# Staff Report Z-36-19-6 (44 Camelback PUD) September 20, 2018

Request From: C-O (17.72 acres)
Request To: PUD (17.72 acres)

Proposed Use Planned Unit Development to allow a mixed-use

Proposed Maximum Heights; Source: SmithGroup, annotations by City of Phoenix Planning and Development Department

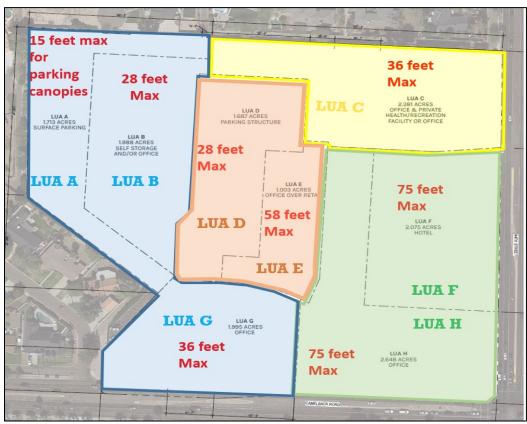
The proposed heights, with exception of the 75-foot height in LUAs F and H, are comparable to or more restrictive than the C-O/M-O zoning district. The C-O/M-O district permits a maximum height of 56 feet adjacent to non-residential districts. When adjacent to a residential district, there is a step back standard that limits the

82 feet from the northern property line. This standard is identical to the PHO stipulated requirement of 36 feet maximum within the boundaries of Rezoning Case No. Z-274-79. Staff is recommending that the height standard in LUA E be reduced

to a maximum building height of 56 feet in order to minimize heights in excess of 56 feet and concentrate the additional height at the intersection. This is addressed in Stipulation Nos. 1.b. and 1.e.

- Restrict modifications to LUA B.
- d. Page 16, Add header to top of Land Use Table.
- e. Page 19, Development Standards, Maximum Building Height, LUA E: Modify building height to 56 feet maximum.
